**Car Stereo
Service Bulletin**

Model: CDX-A100

No. 182

Subject: Sound Distortion Heard In Play Mode

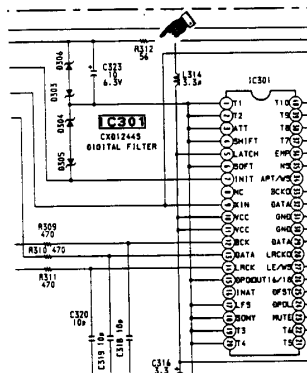
During Play mode, sound distortion is heard synchronizing with sound signal, especially when high frequency component sound is played back. This could be monitored by using a test disc YEDS 18, and scoping the sine wave.

Solution: If this symptom occurs, change R312 (resistance for unwanted radiation control) from 56 Ohm to 3.3 Ohm.

Ref. No.	Description		
	Former	New	Part Number
R312	Metal Glaze 56 Ohm	Metal Glaze 3.3 Ohm	1-216-138-00
